Attachment (3)
Definition of Holes to be Modified for ALL Type A MCWFs
(Reference: D.Williamson e-mail of May 4, 2006)

NCSX RFD	Number: 14-018		RFD Description: Type A MCWF Flange Hole Modifications				
IPart III			Tiole Widdiffications				
RLM: Brad Nelson		Organization: ORNL					
Impact on Interfaces with Other WBS Elements/Items: (If none, so state): NONE							
RLM Recommendation:							
Additional remarks:							
This RFD also includes a modification by the NCSX Project for all the Type A MCWF flange holes. The minimum stud clearance required behind the tapped holes shall not be less than ½" to ensure full thread engagement.							
These modifications will be incorporated in a future revision to this drawing. In the interim that "stamp" process will be used to annotate SE141-114.							
Does this Change Impact Material Already Procured or Parts/Assemblies Already Assembled/Manufactured using this Material: \boxtimes Yes \square No							
If "Yes", what is the recommended disposition of this material/part/assembly? A1 Casting will be accepted "as is" with the exception of the two holes shown.

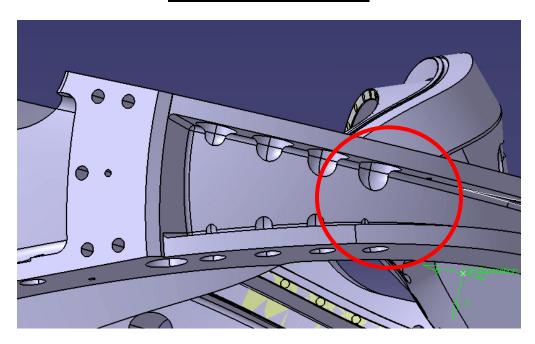
Major Tool noted casting interference at the bolt locations shown in the attached figures for the Type A1 casting. For the A1 casting details shown on SE141-114, the two holes will be changed from clearance holes to tapped holes as shown n Attachment (1) in which MTM describes the areas of interference. This casting interference is similar to what was noted on the Type C winding forms, but more severe in these areas. PPPL letter (L. Sutton to N. Horton) dated April 20, 2006, authorized this change for the A1 casting as shown in Attachment (2).

Attachment (1) Type A MCWF Interferences

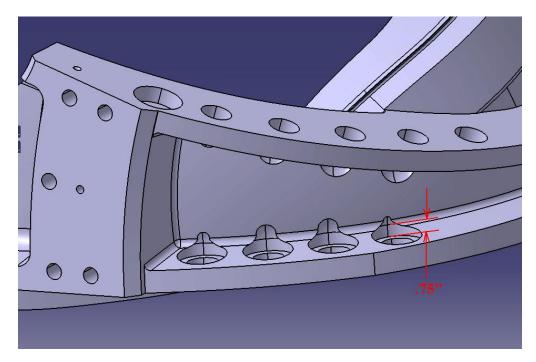
Relief area cut into cast wall

The pictures below illustrate how much casting wall interference there will be on the type A casting. The current machining models for all three winding forms have this interference problem to some degree. The models have a 3" counterbore that extends .75" from the face and the remainder of the feature is a 1.5" radius (see below). This is why Major Tool had to perform the grinding around the counterbores on C4 in order to get the 3" diameter gage to fit.

SE141-114 MCWF TYPE-A1

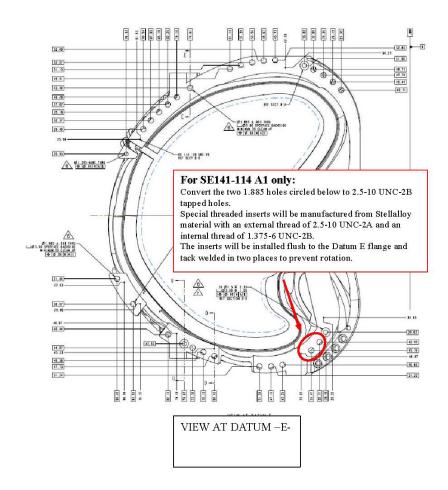
Proposed change to 1.885 thru holes

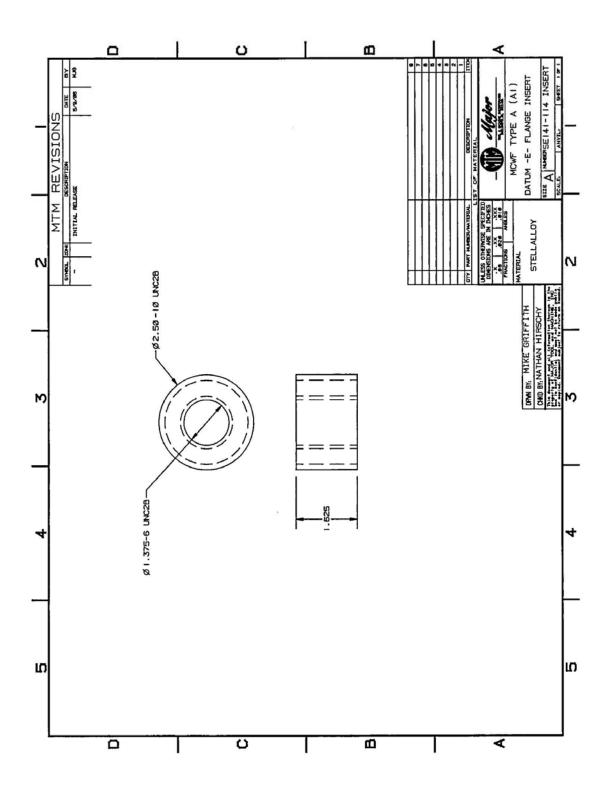
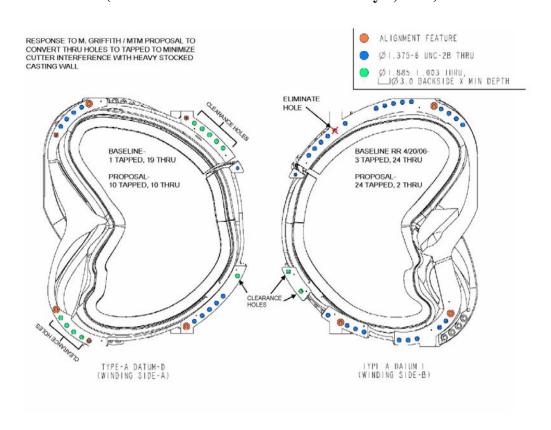
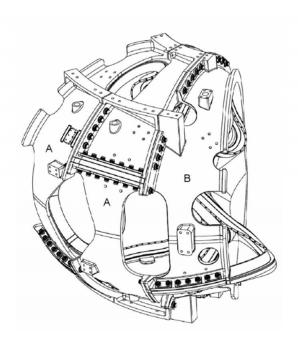
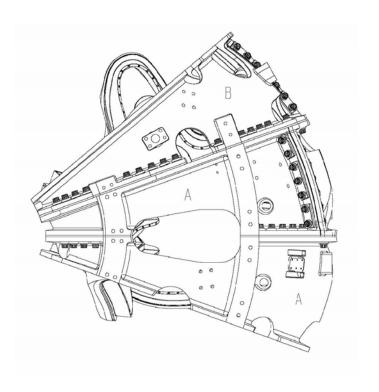
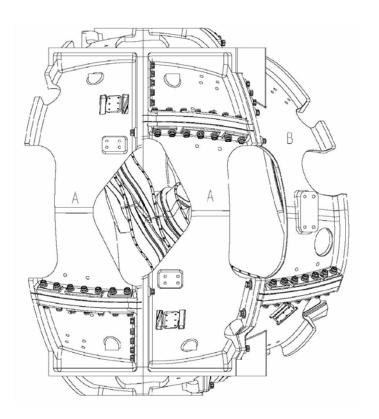
In response to this, NCSX reviewed remaining flange holes all the Type A castings and developed the concept shown on Attachment (3) in which a number of the clearance holes have been changed to tapped holes. All Type A MCWFs shall be manufactured per this.
